# ADDENDUM # 1

# IFB #2882 Improvements to Ebenezer Park Phase II

subject: Addendum No. 01 Improvements to Ebenezer Park Phase II Rock Hill, South Carolina ADC Project No. 21435

# L303

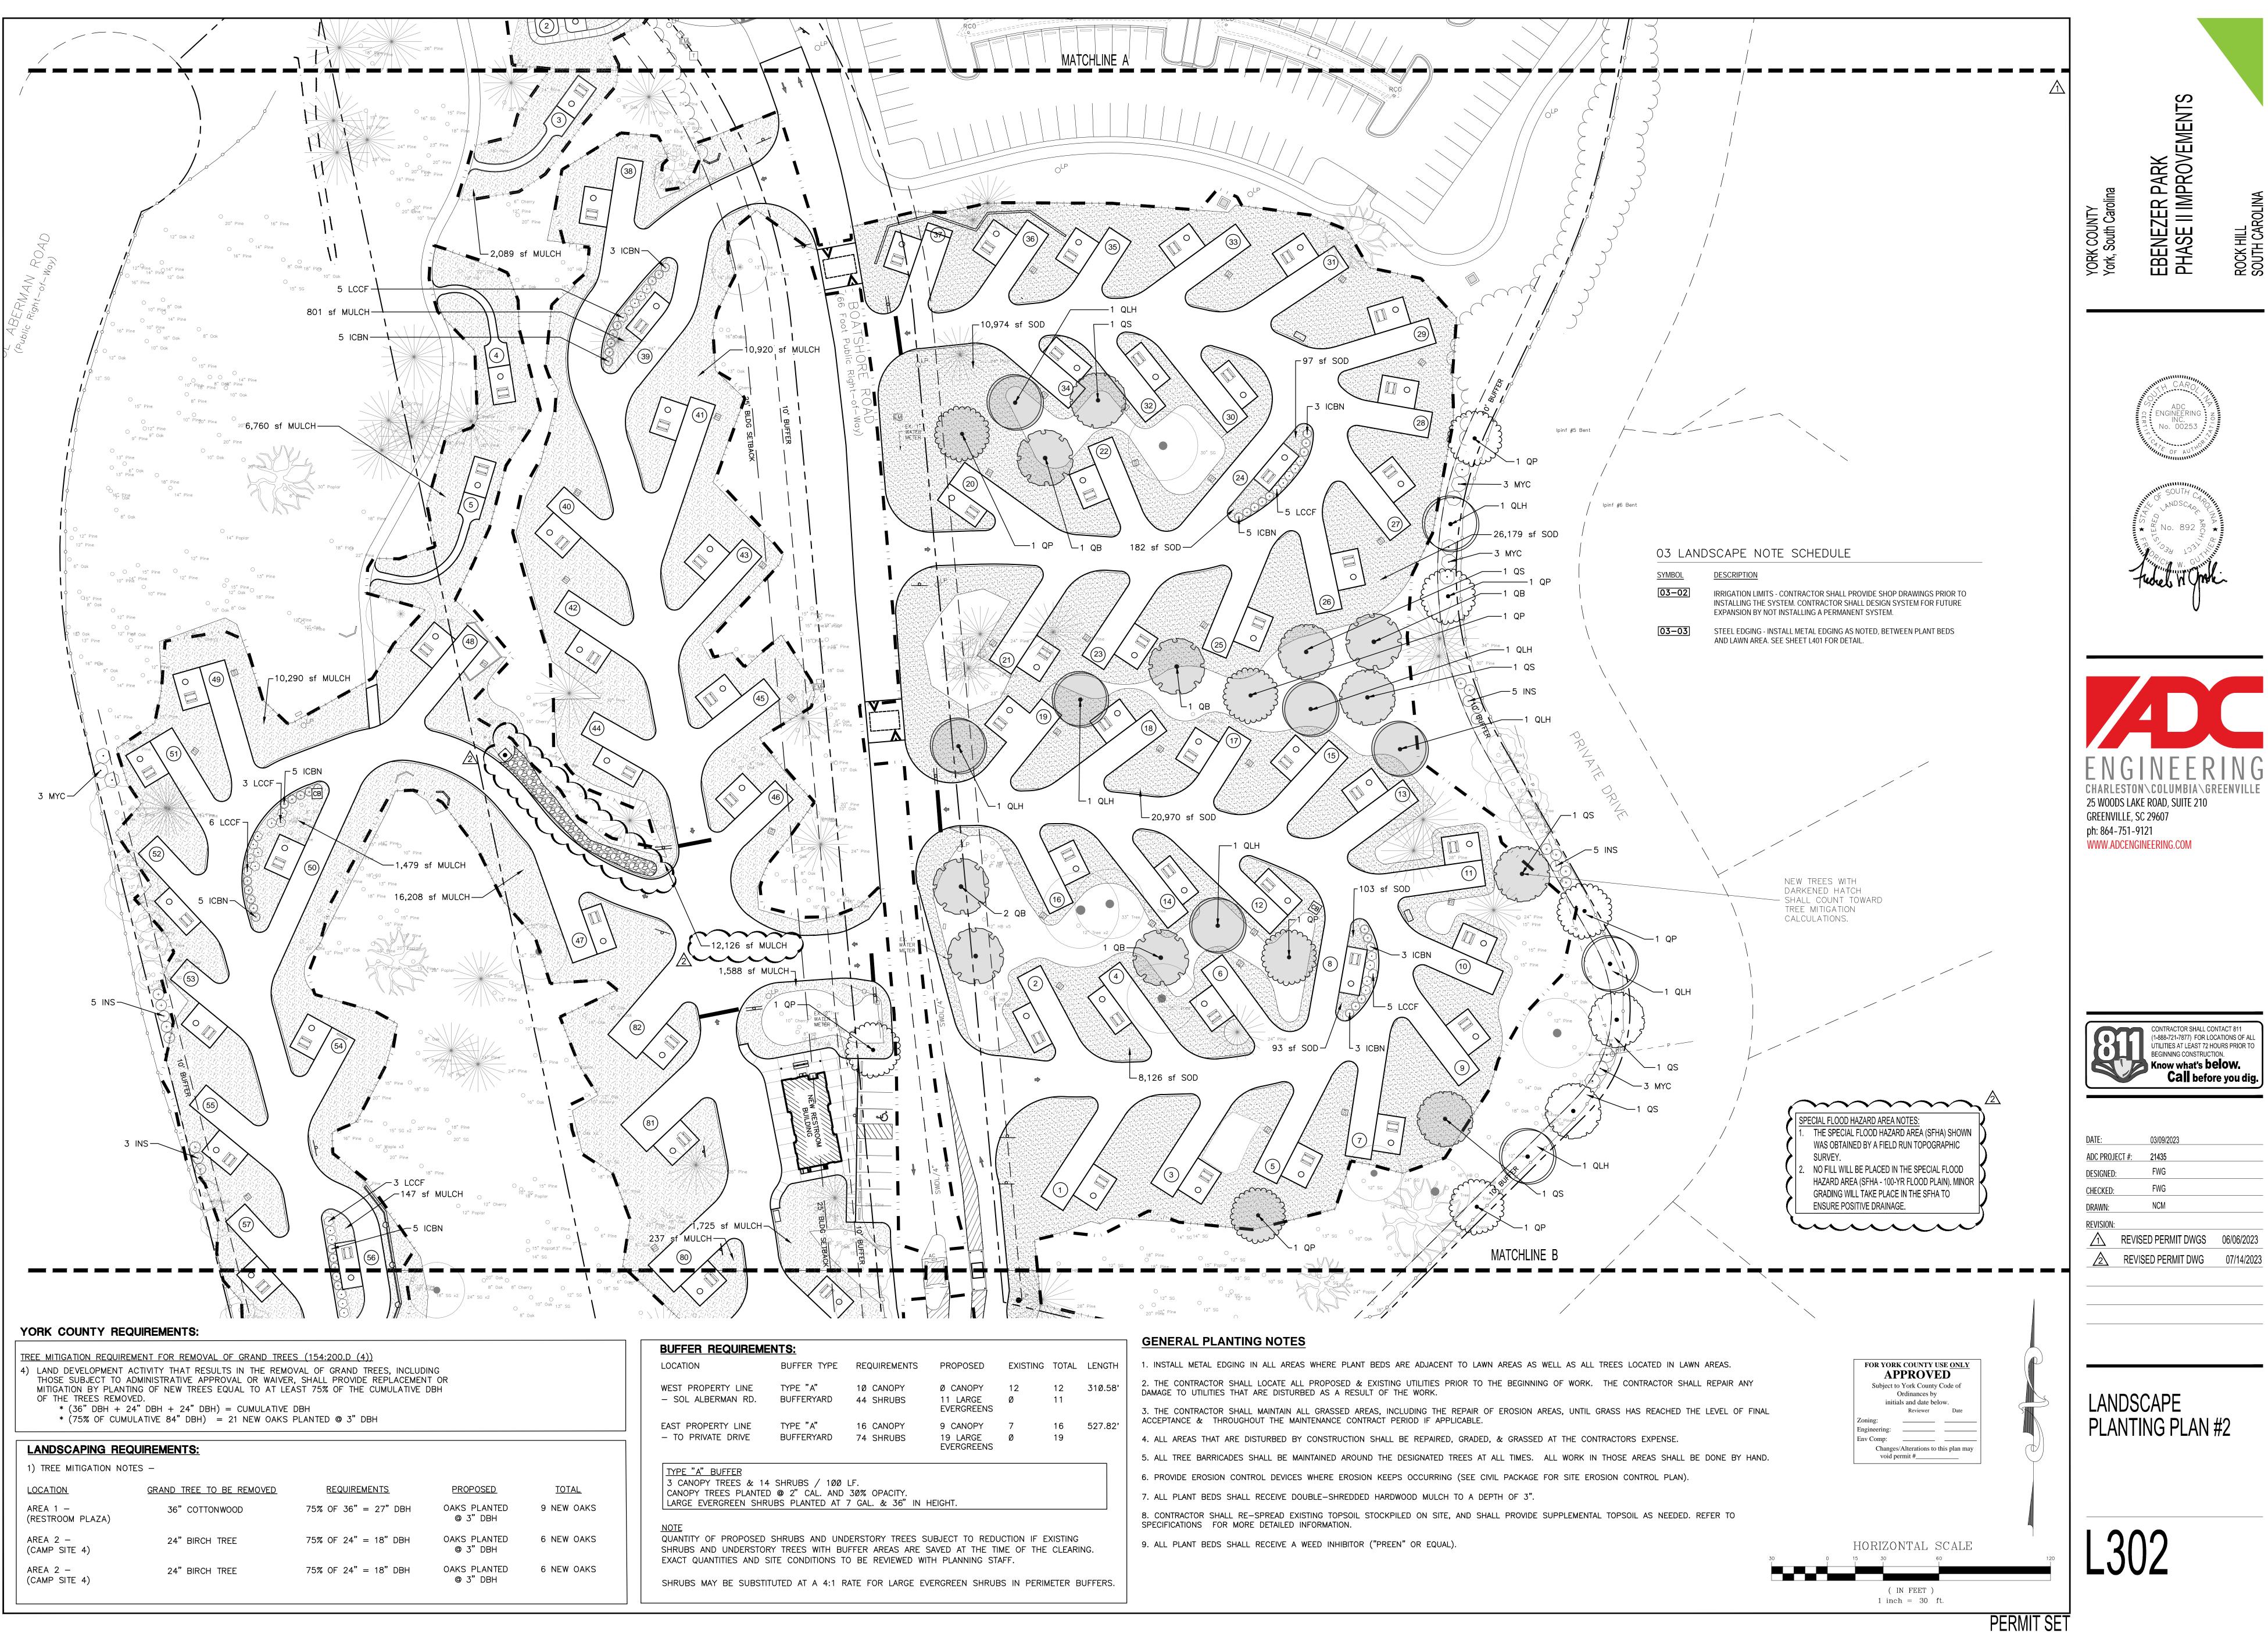
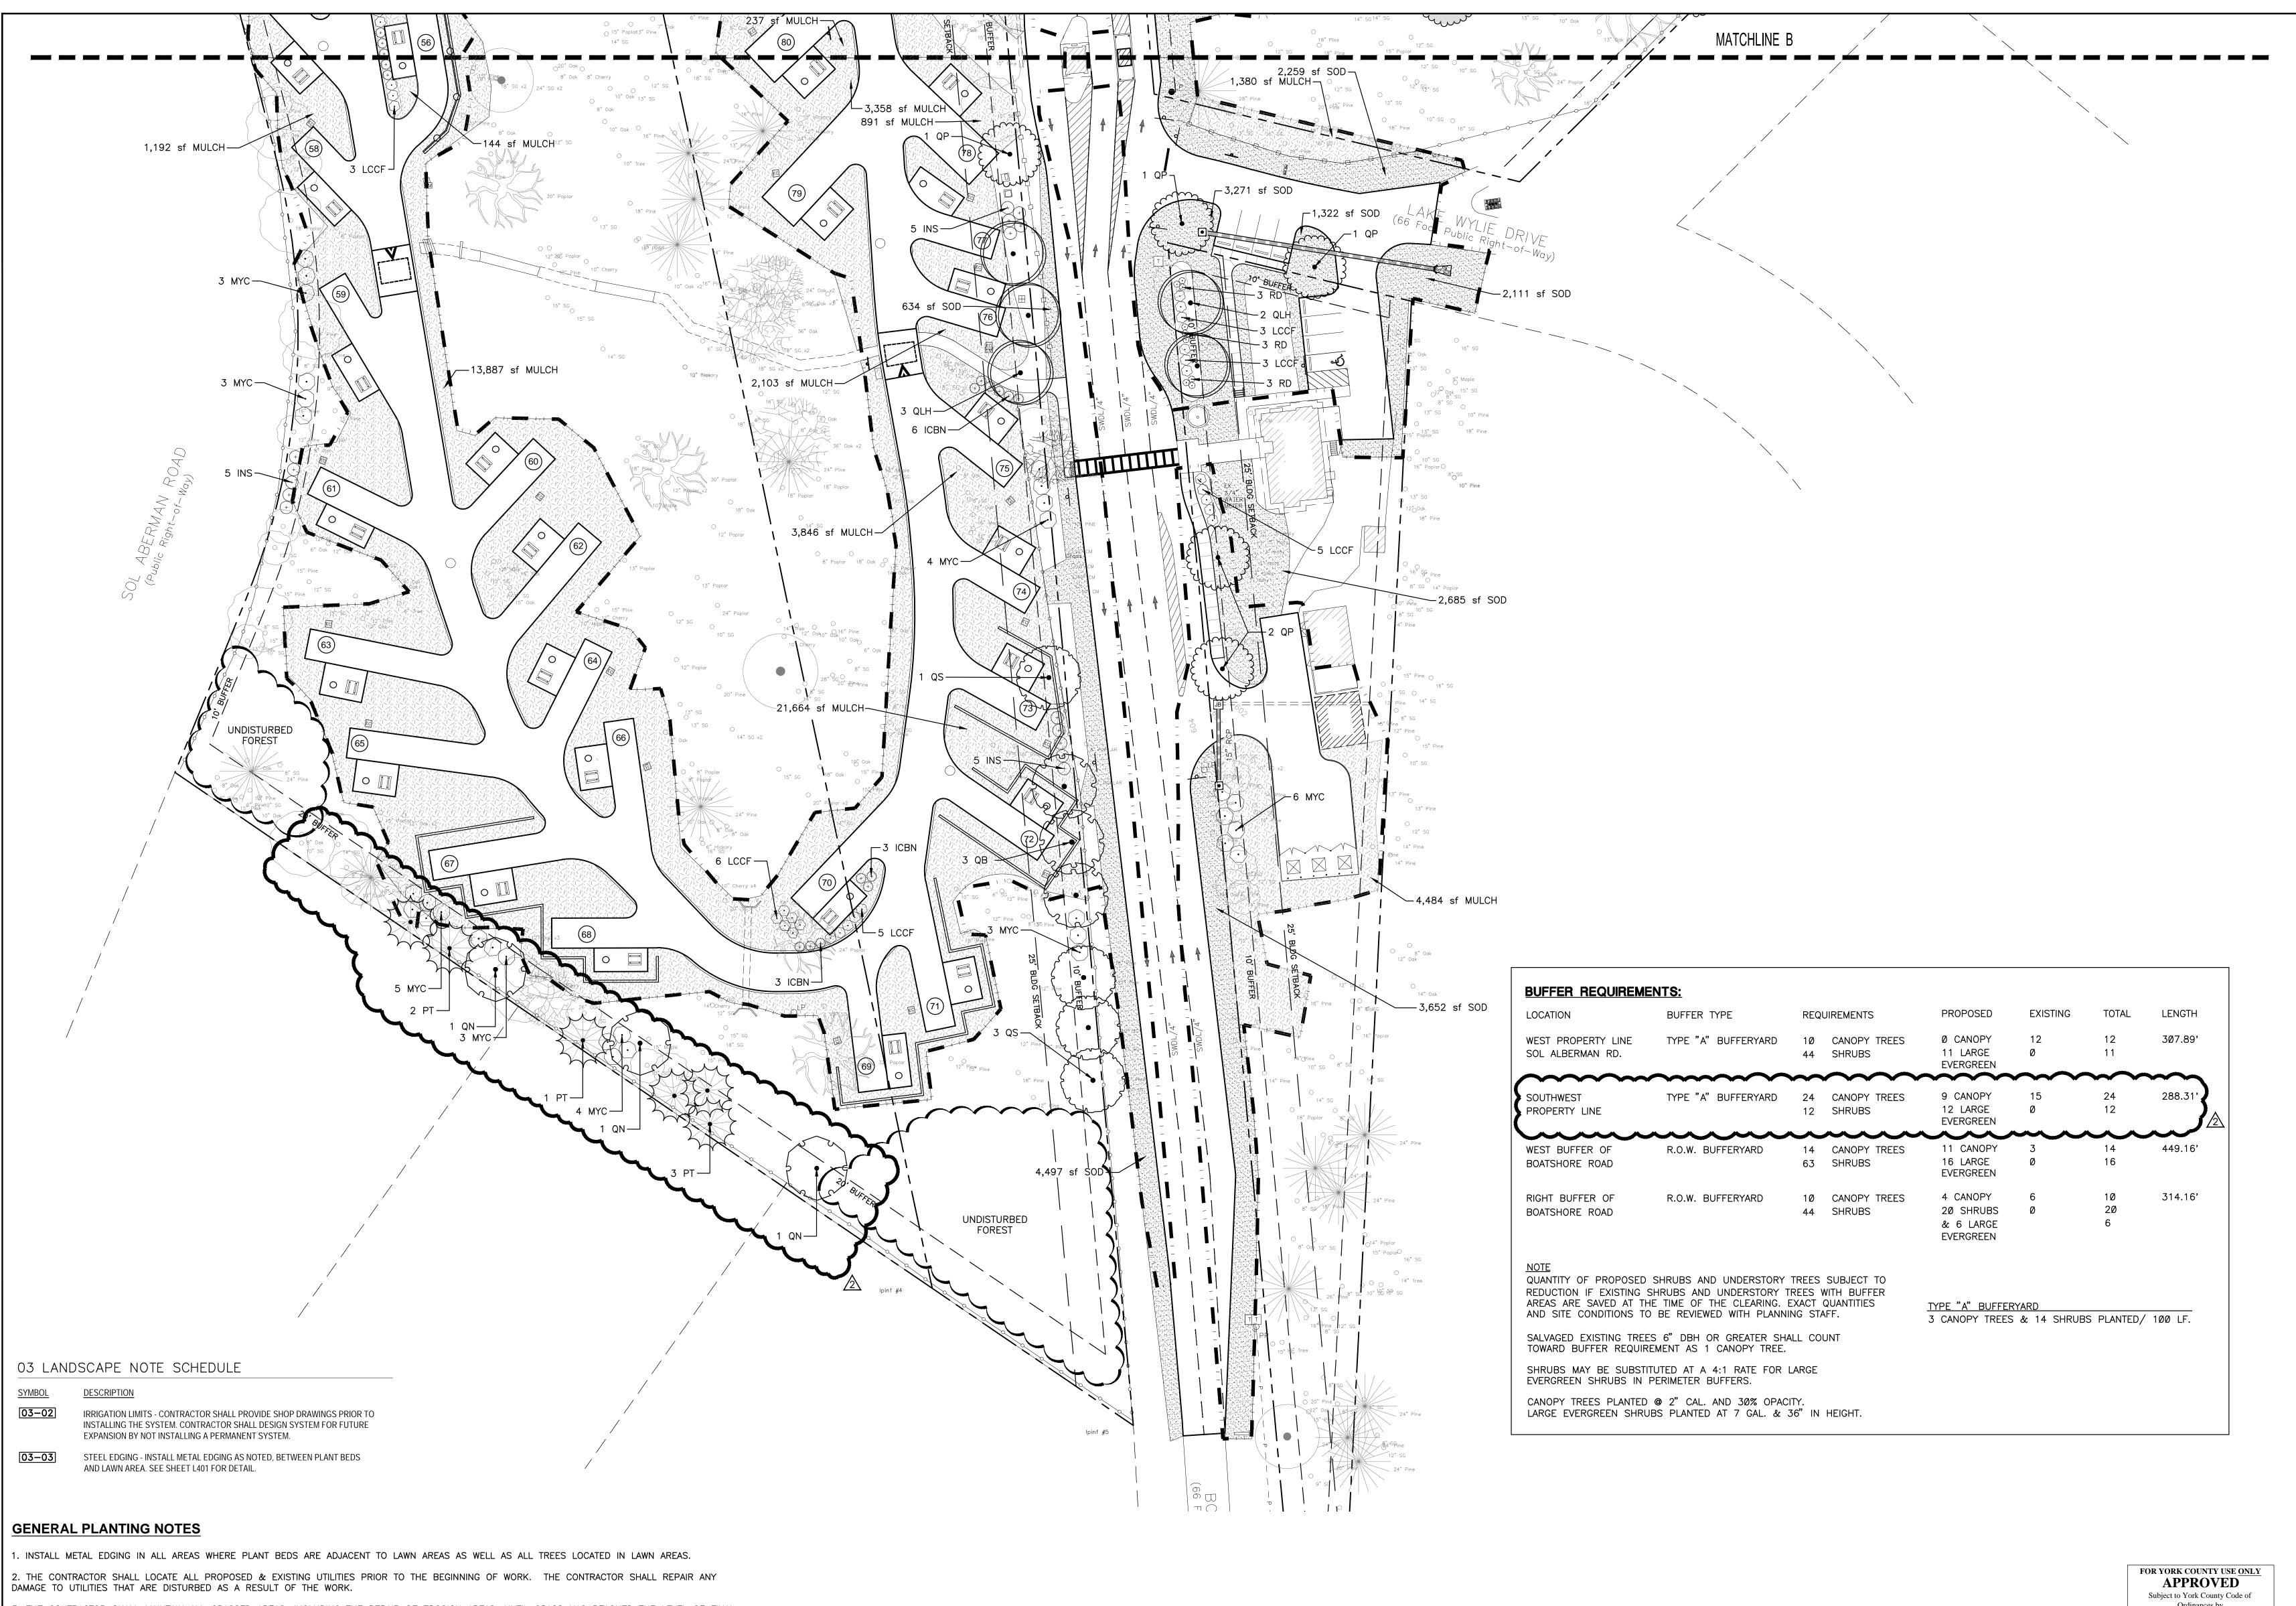
a. Additional landscape buffer plantings along the southwest property line.
